Subject: FCC Class II Permissive Change for FCC ID: XEU2703240

In this memorandum, I am providing details of modifications to the existing Rockwell Collins Model Number, 270-3240-020, FCC ID: XEU2703240, for consideration of Class II Permissive Change.

Figure 1 Transceiver Board Top without Shielding

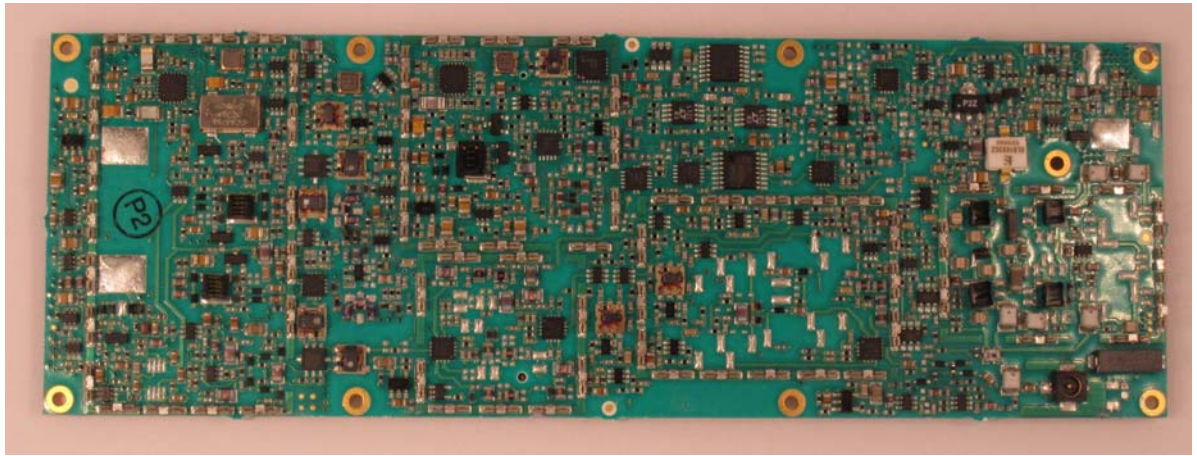
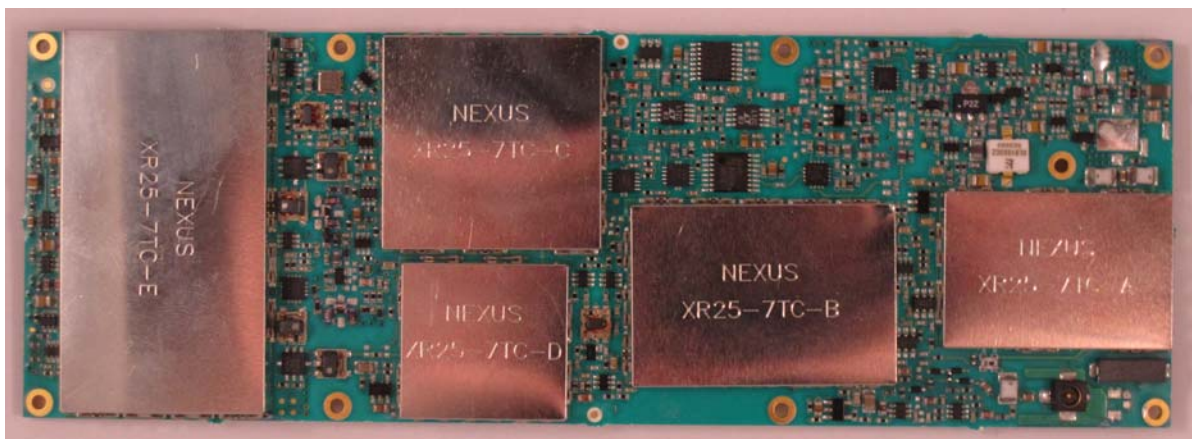
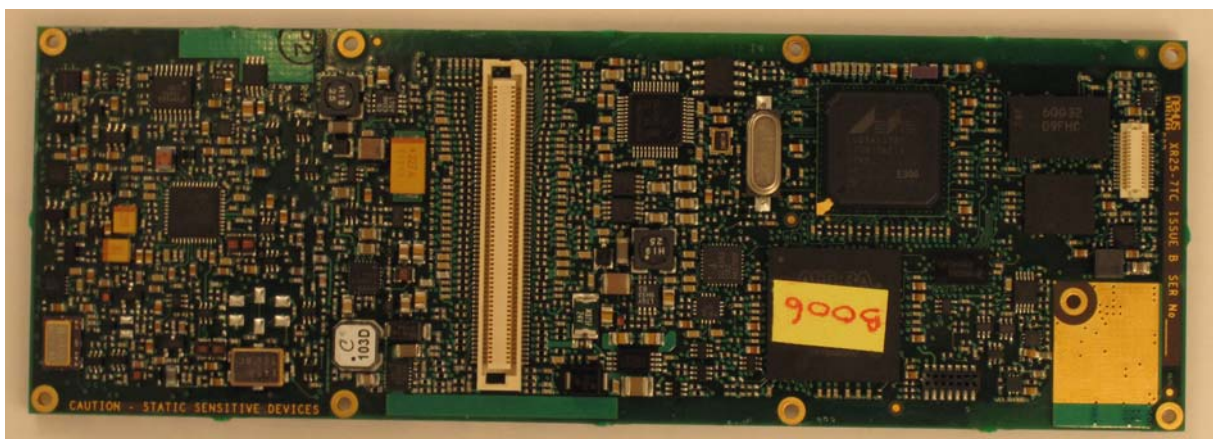
Update	Reason	Details
First Rx RF LNA Optimised	Optimised to improve Inter-modulation performance.	Supply voltage altered.
Second Rx RF LNA	Optimised to improve Inter-modulation performance.	Supply voltage altered, attenuation added.
455MHz Rx LNA	Optimised to improve Inter-modulation performance.	Supply current and transistor matching improved, attenuation added.
455MHz Rx IF Saw Filters replaced by Discrete Filters	Improve Receive Inter-modulation performance	Avoid interaction between SAW filters and active devices.

Update	Reason	Details
Tx/Rx switch	Incorporating modifications from previous design on to PCB.	Minor tracking changes.
455MHz Rx LNA	Incorporating modifications from previous design on to PCB.	Layout changed to fit new circuit topology, to improve signal flow and input/output isolation.
455MHz Rx IF Saw Filters replaced by Discrete Filters	Incorporating modifications from previous design on to PCB.	Layout changed for new circuit topology.
TX VCO	Incorporating modifications from previous design on to PCB.	Minor layout change for different sized parts in VCO. Replacing previous transmit path elements with new topology.
TX VCSO	To avoid radiated spurious.	Minor tracking change.

Update	Reason	Details
Tx VCO RF Shielding extended	Extended shielding to cover Tx VCISO filtering and mixer.	Improved screening & layout.

Figure 4 Carrier Board Top

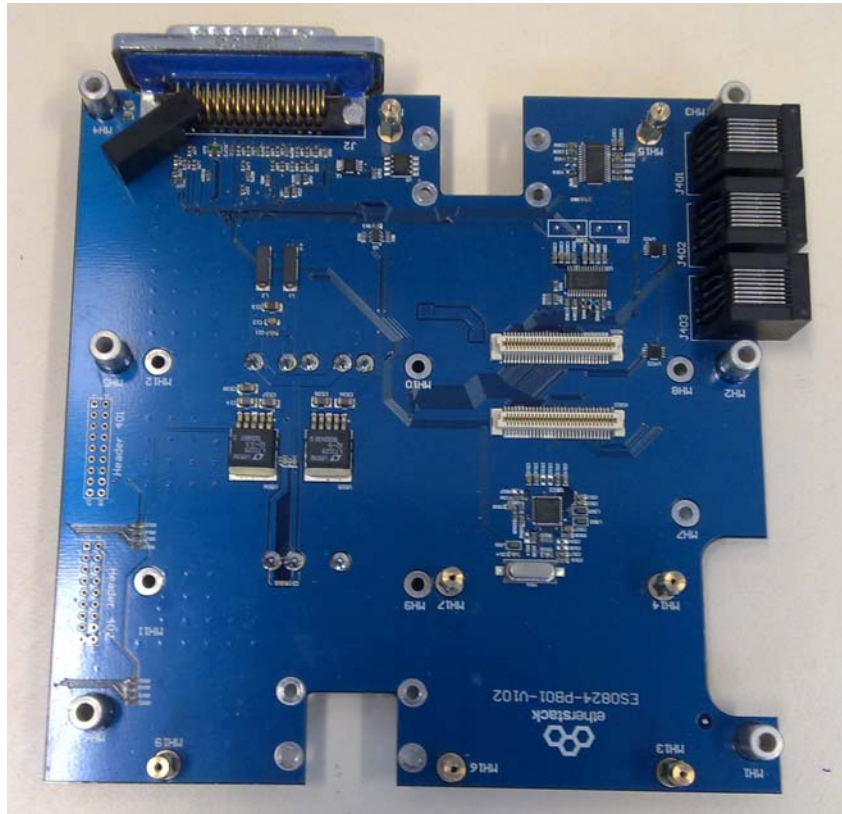
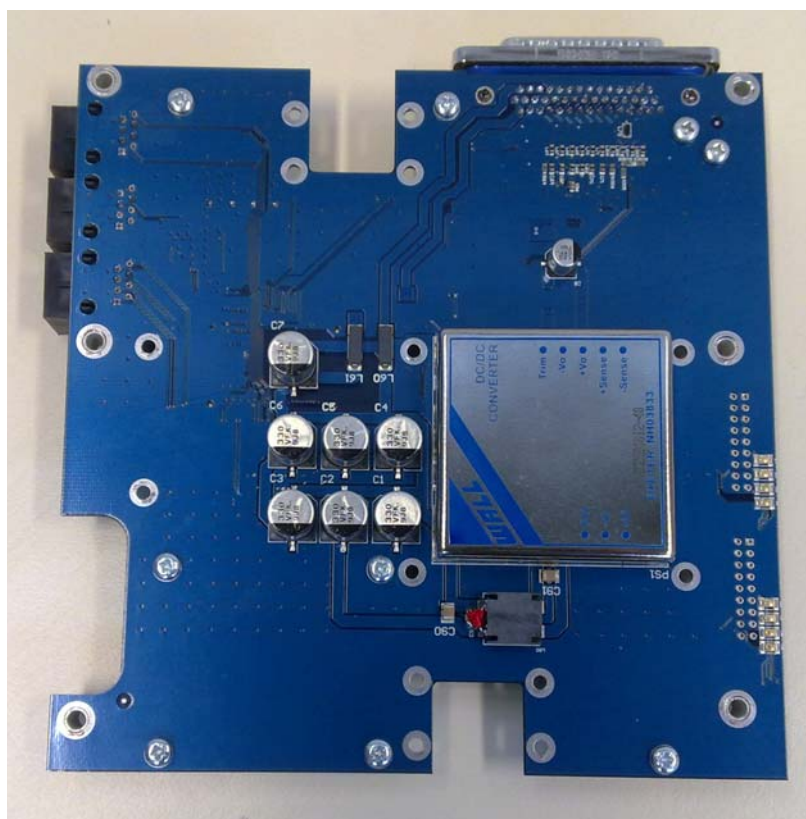
Update	Reason	Details
RS232 IC changed	Manufacturing and maintenance	2 x MAX3243E replace 2x ISL4243EIRZ
Addition 8 indicator LEDs	Assist product maintenance	Parts. 4 x SML1209-0ER-TR 4 x SML1209-0UG-TR
GPIO Header lines removed	8 GPIO lines removed to allow for LED signals from daughter card	
Power Supply Filtering	To improve Power supply filtering to meet FCC Part 15 class B.	Addition of ACM1211-102-2PL choke to provide additional noise suppression on power lines.
Grounding of all Mounting holes	To provide improved transceiver grounding to chassis

Update	Reason	Details
Location of GPIO Headers changed	Location moved closer to side access cover	401 and 402 moved from RF connector side of PCB to opposite board edge near access cover
General	Traces relocated to provide greater clearances between mechanical mounting holes

Update	Reason	Details
RF Connector Cut Out	To facilitate production and maintenance	PCB cut out, located under the RF connectors
DSUB44 Cut Out	To prevent physical interference with the rubber seal of DSUB44	PCB cut out, located under DSUB44
Updated Transceiver and Daughter card mounting	Improve mechanical integrity, grounding and assembly.	Added 2 Carrier to VRS2 Transceiver standoffs to replace above standoffs. Added new Carrier to VRS1 Transceiver standoff Moved location of the six Carrier to daughter board standoffs

Figure 7 Daughter Board Bottom

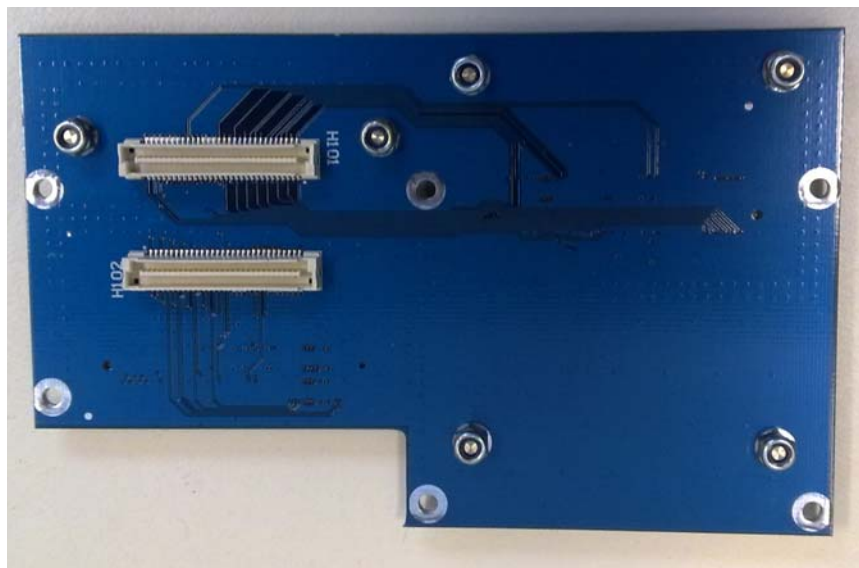
Update	Reason	Details
LED Signals Added	New GPIO signals to control LEDs added, and unused GPIO signals removed	
Mounting Holes grounded	Mounting holes grounded to provide improved Transceiver grounding

Update	Reason	Details
Updates to reflect Schematic changes

Update	Reason	Details
RF Connector Cut Out Added	RF Connector cut out added to improve assembly	
Location Change of Daughter to Carrier Mounting holes	Mounting holes moved to due to updated Daughter board dimensions as a result of daughter board cut out.

Figure 8 Internal Base showing Heatsinking

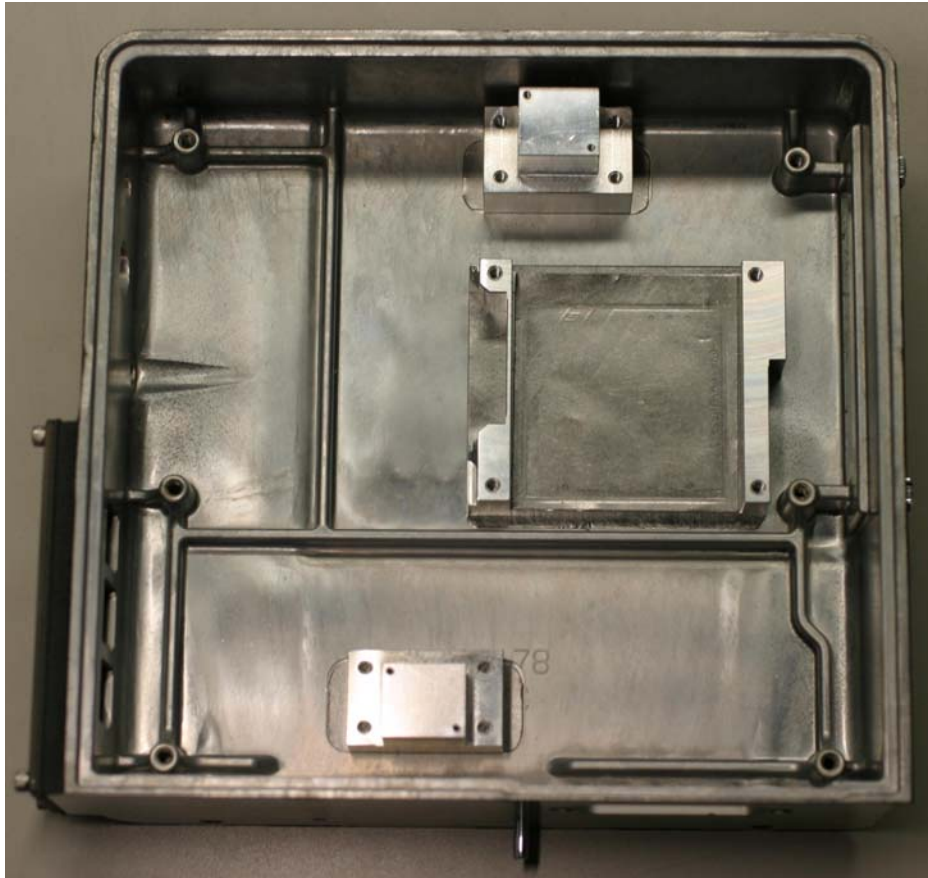
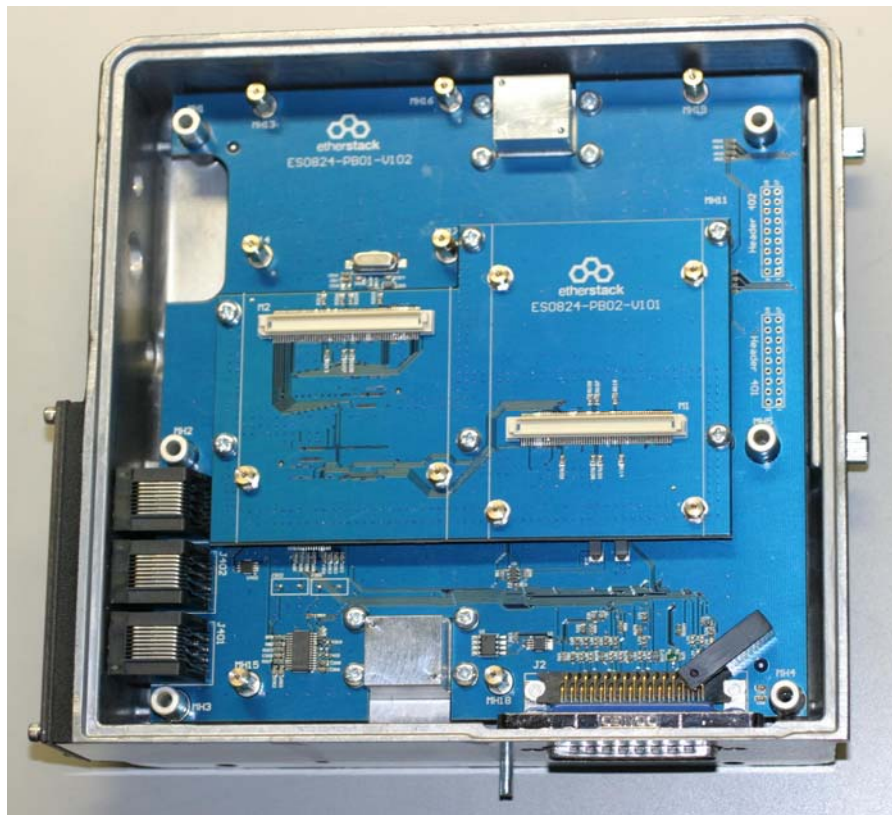
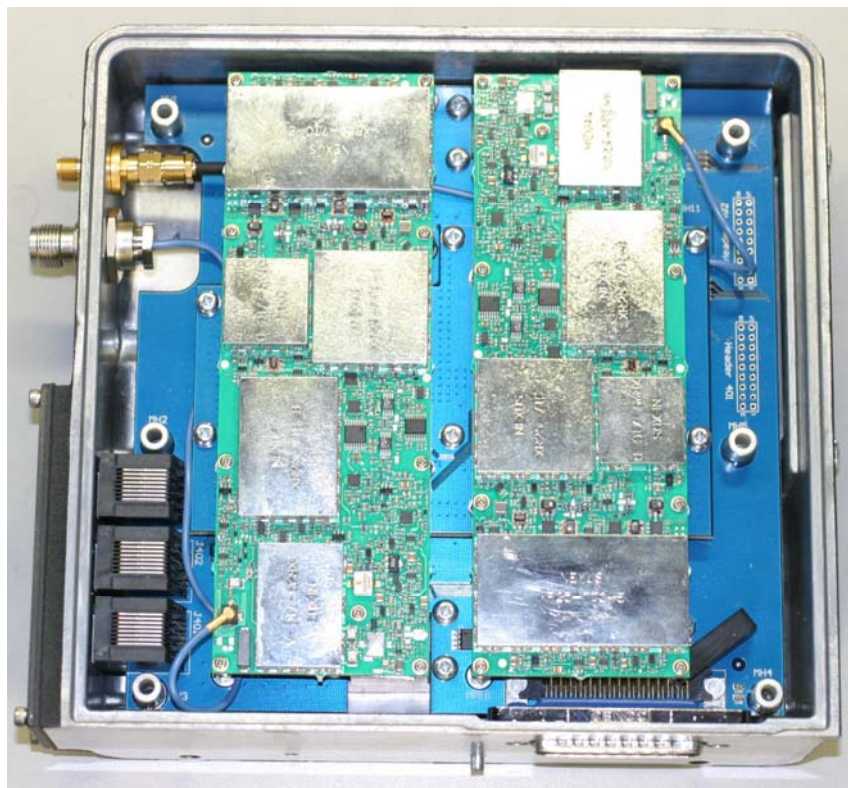
Update	Reason	Details
Updated Transceiver and Daughter card mounting	Improve mechanical integrity, grounding and assembly.	Removed two Daughter card to Transceiver standoffs. Added 2 Carrier to VRS2 Transceiver standoffs to replace removed Daughter card to Transceiver standoffs. Added new Carrier to VRS1 Transceiver standoff, using right angle standoff. Moved location of the six Carrier to daughter board standoff.
Power Converter Heatsink	Improve heat dissipation from DC-DC Converter	Added machined aluminium heatsink in place of padded heatsinks.
Heatsink retaining screws	Improve heat dissipation and mechanical integrity	Screws added to fasten heatsinks against chassis.
